Access Compliance Report Public Rights-of-Way (Curb Ramps)

Intersection ID: N/A	Main Street: PERTH_MOOR_RD	Cross Street: HAMILTON_BRIDGE_RD	Location: NE
ADA ID: 9CEF522D1758	Ramp Type: Perp	Initial Pass/Fail: Fail	Overall Compliance: No
Severity Score: 58.75			
Codes/Mitigation Info/Possible Solution		Field Measurements/Component Compliance

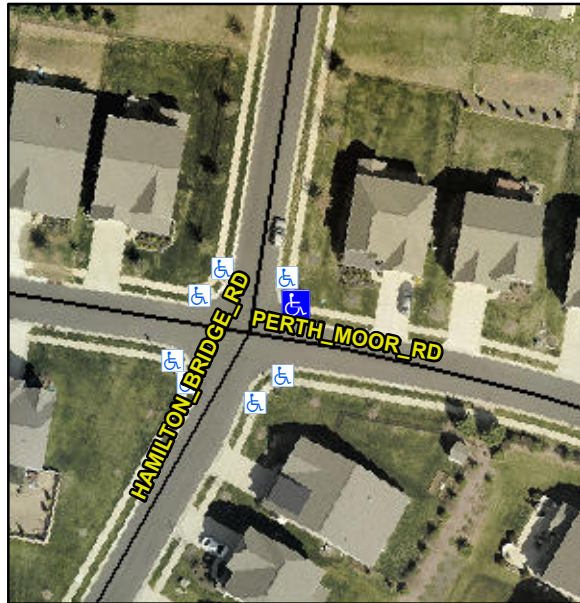
Remove & Replace Entire Ramp.

R304.5.1, R304.2.2, R304.5.3

Compliance	Description	Data	Compliance	Description	Data
N/A	Ramp Length (in)	47.0	No	Ramp Slope (%)	13.1
No	Ramp Width (in)	44.0	No	Ramp XSlope (%)	11.2
N/A	Flare Type LT	N/A	N/A	Flare Type RT	N/A
N/A	Flare Slope LT (%)	N/A	N/A	Flare Slope RT (%)	N/A
N/A	Flare Traversable LT?	N/A	N/A	Flare Traversable RT?	N/A
N/A	Landing Length (in)	N/A	N/A	DWS Provided?	N/A
N/A	Landing Width (in)	N/A	N/A	DWS Contrast?	N/A
N/A	Landing Slope (%)	N/A	N/A	DWS Length (in)	N/A
N/A	Landing X Slope (%)	N/A	N/A	DWS Full Width?	N/A
N/A	Landing Curb? (Y/N)	N/A	N/A	DWS Offset (in)	N/A
N/A	Shared Landing?	N/A			
N/A	Gutter Ponding?	N/A	N/A	Gutter Slope (%)	N/A
N/A	Gutter Lip Ht (in)	1.5	N/A	Gutter X Slope (%)	N/A
N/A	Painted X Walk1?	No	N/A	Painted X Walk2?	N/A
	X Walk 1 Direction	To SW		X Walk 2 Direction	N/A
N/A	X Walk 1 Width (in)	N/A	N/A	X Walk 2 Width (in)	N/A
	X Walk 1 Slope (%)	2.5		X Walk 2 Slope (%)	N/A
	X Walk 1 X Slope (%)	2.7		X Walk 2 X Slope (%)	N/A
